**Item #1 Tandem Vector Modification**

**Item #3 Loose Fitting on Vectors**

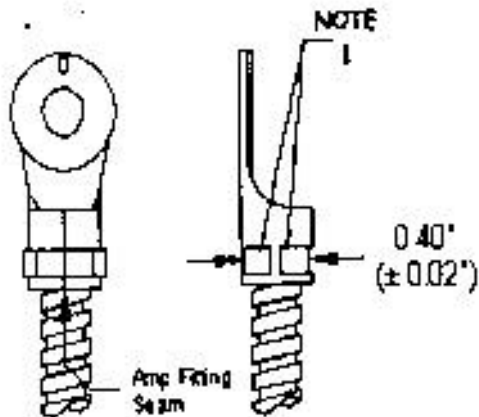
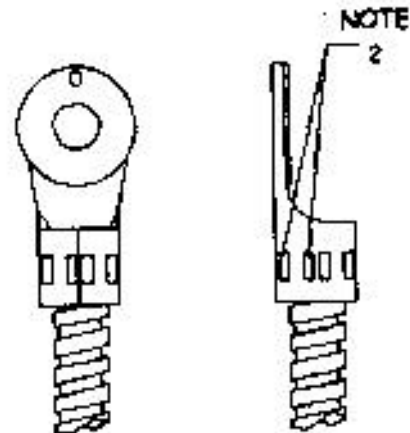
Although Service Bulletin #091098-B was issued in 1998, there may still be a number of Relative Workshop Vector Systems manufactured after 1 January 1996, which have not been checked for loose AMP fittings on the canopy release housings - riser end.

Incorrectly swaged fittings may not be secure and can be twisted off using only finger pressure applied in a certain direction. This could result in the canopy release cable being activated accidentally.

Note 1 - A correctly swaged AMP fitting has two semicircular indentations.

Note 2 - An incorrectly swaged AMP fitting has numerous small indentations around the fitting.

Inspection may require removal of the shrink-wrap. Incorrectly swaged fittings need to be repaired immediately. Copies of SB#091098 are available from Relative Workshop.
